Informal document GRSP-75-27
(75th GRSP, 27-31 December 2024)

GRSP UNECE R14 Workshop on Extended Use
Positions

27.05.2024 | B. Lorenz | BAST

OICA Proposal for R14 Extension

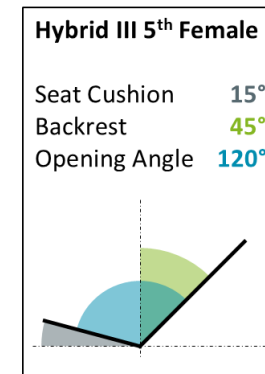
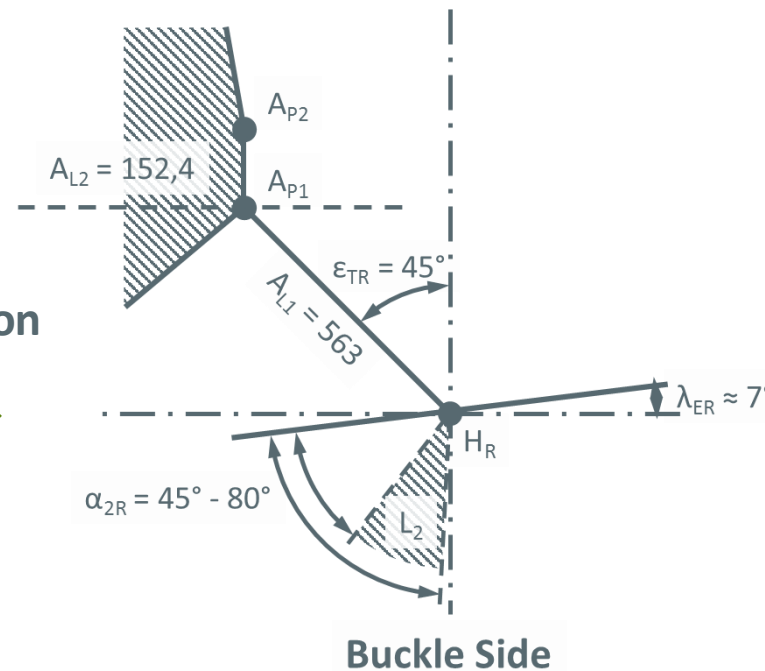
- ▶ Permitted area is redefined for extended use positions (WSR14_8):
 - ▶ Upper anchorage point rotates with the backrest
 - ▶ Lower anchorage points are dependent on the change in the seat cushion and backrest inclination

Workshop: OICA Proposal for R14 Extension

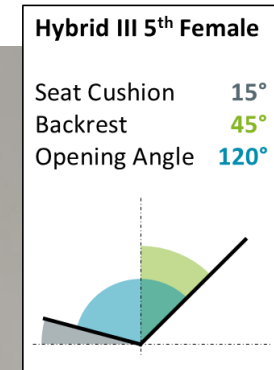
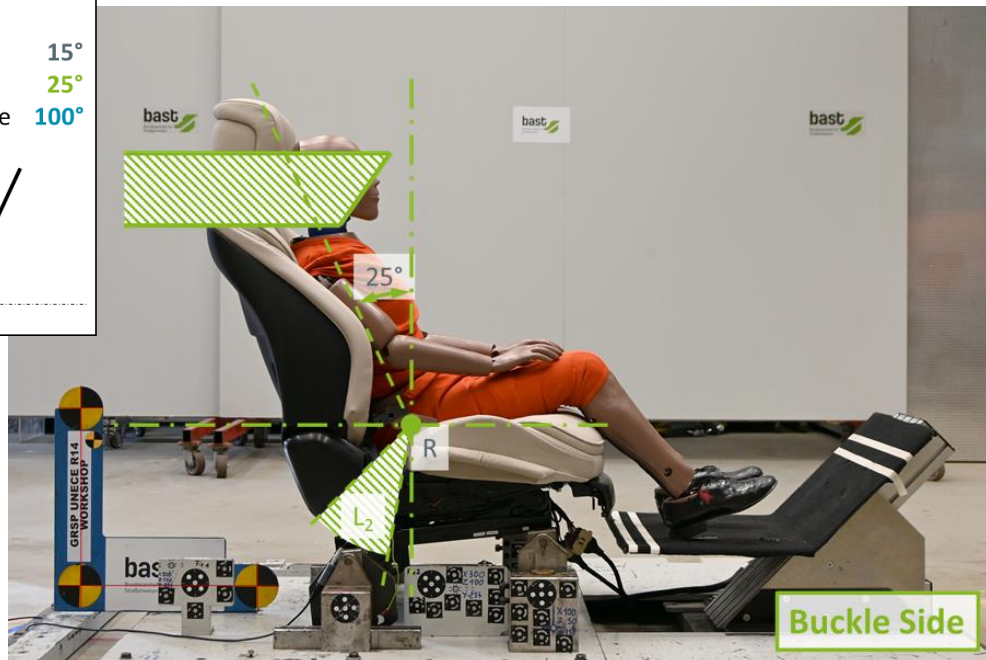
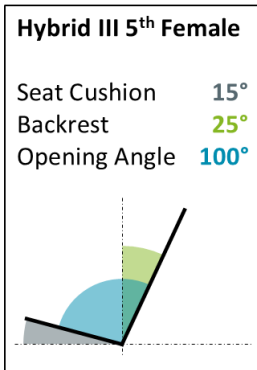
- ▶ Discussion of OICA's proposal (WSR14_8) in a vehicle seat with different configurations and different dummies:
 - ▶ No continuous contact between back and backrest for the Hybrid III family for 120° opening angle
 - ▶ Proposal to extend the R14 was positively received
 - ▶ Proposed area probably too high for an optimal belt routing for small occupants
 - ▶ The proposal allows L1 and L2 to be located in front of the H-point
